Work Order ID 99723

Item Name: Crosstube Aft

DRAWING NO. D212-664-241	TITLE CROSSTUBE ASSY (205/212 HI AFT)	REV. D	DART AEROSPACE LTD ENGINEERING ORDER		D.E.O. NO. D212-664-241-D-1	SHEET NO. SHEET 1 OF 2	SCALE NTS
DRAWN	CHECKED	MFG. APPR.	APPROVED	DE APPR.			
DATE 11.04.07	DATE 11.04.11	DATE 11.04.12	DATE 11/04/12	DATE 11.04.12

ADD AN INSPECTION WINDOW TO UNDERSIDE OF CROSSTUBE.

**D212-664-241/-241B
ASSEMBLY DETAIL**

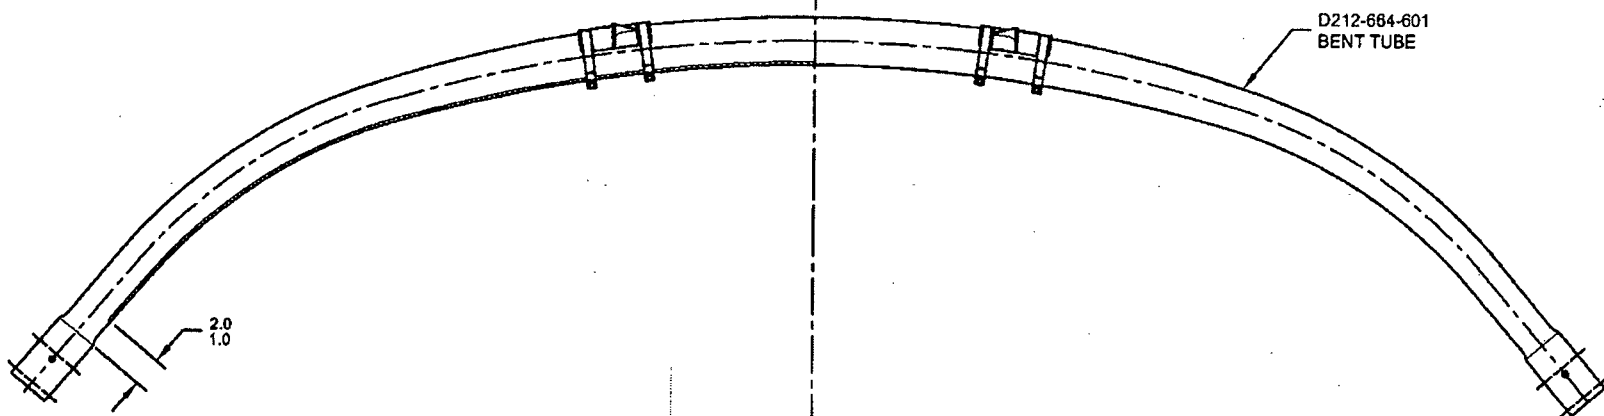
NOTES 2 OF SHEET 1 IS AMENDED AS FOLLOWS:

- 2) FINISH: CHEMICAL CONVERSION COAT PER DART QSI 005 4.1
PRIME INSIDE AND OUTSIDE PER DART QSI 005 4.2
MASK UNDERSIDE OF CROSSTUBE AS SHOWN (HATCHED AREA) AND
PAINT OUTSIDE PER DART QSI 005 4.2
REMOVE MASKING AND APPLY CLEAR COAT

MASK AREA PRIOR TO PAINTING,
REMOVE MASKING AFTER PAINT
AND APPLY CLEAR COAT

FIGURE 1: SUPPORT INSTALLATION

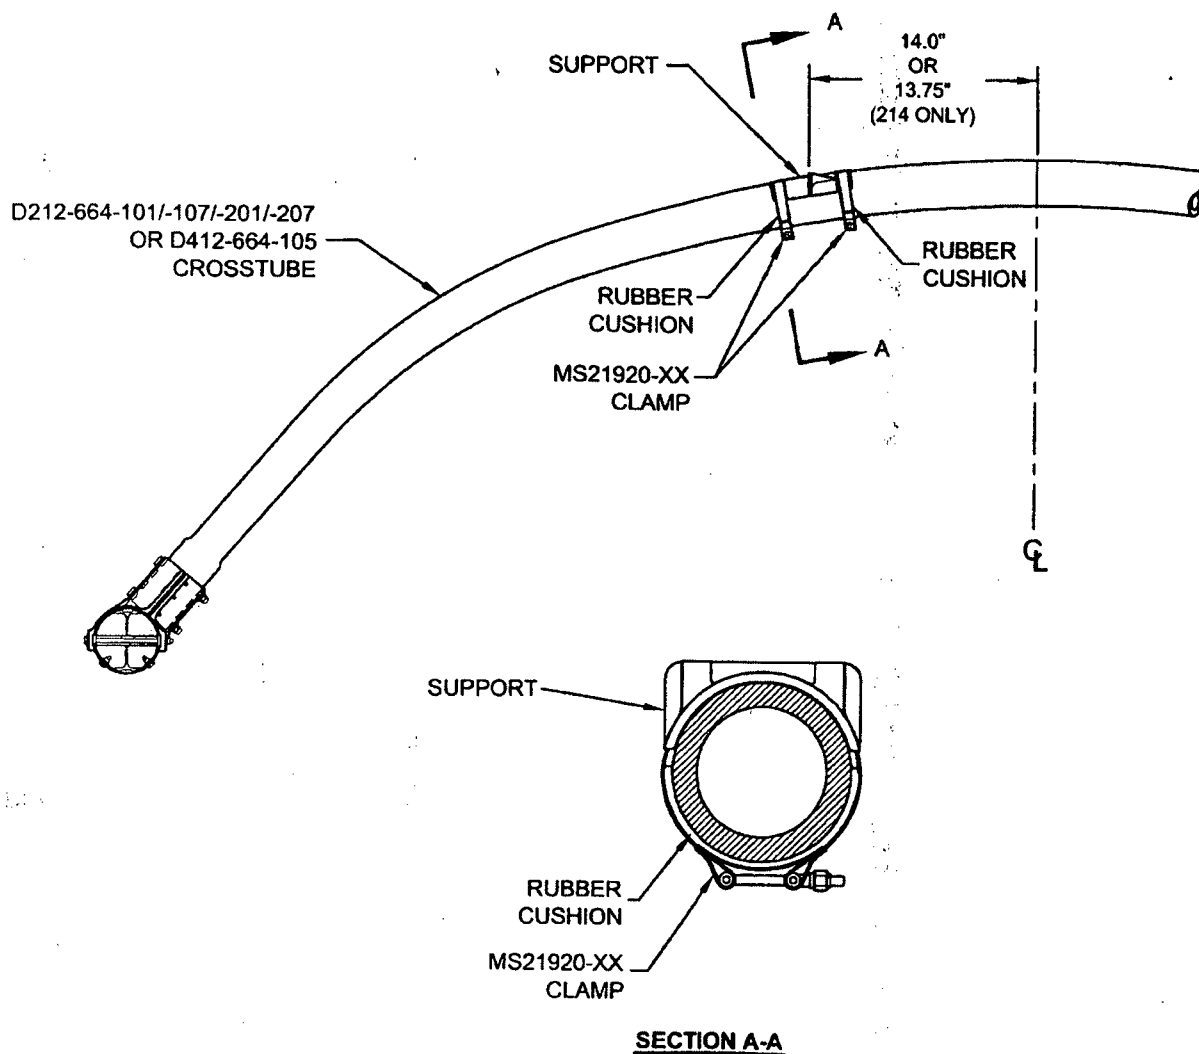
For the crosstubes listed above, section 32.4 of ICA-D212-664 is amended as follows. Use Figure 1 of this service instruction and Figures 32-2 to 32-9 of ICA-D212-664 for further reference. For crosstubes of an earlier change number, it is recommended that if the supports are removed, the supports should be reinstalled using the procedure listed below.

- 32.4.5 Apply a 0.04" to 0.07" thick layer of Proseal 890 Class B or AMS-S-8802 Class B sealant underneath applicable support and install support as shown in Figure 1 of this service instruction.

- 32.4.6 Install the clamps opposite to crosstube support as shown in section A-A of Figure 1. Install rubber cushions underneath each clamp around the bottom circumference of the crosstube up to the crosstube centerline. Torque clamps 80-100 in-lb (9.0-11.3 Nm). It is acceptable to use smaller or larger sized MS21920-XX clamps than those listed in ICA-D212-664, ensure that after torquing the clamps per this instruction, the nuts are in safety but not bottomed out

CRUSHING OF D212-664-201

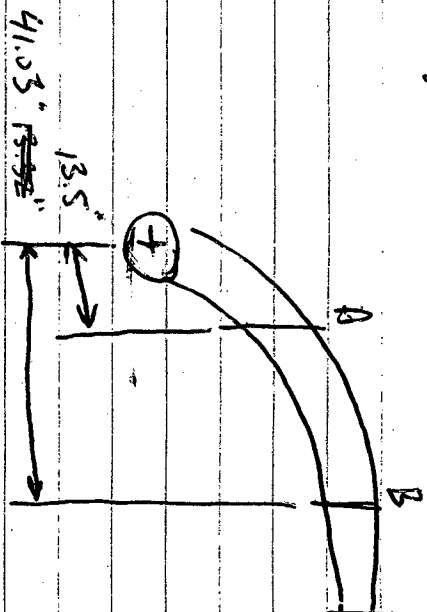
Acceptability of 8% CRUSHING

$$\text{Point A: } OD = 2.548 \text{ in} \quad ODL = 2.442 \text{ in}$$
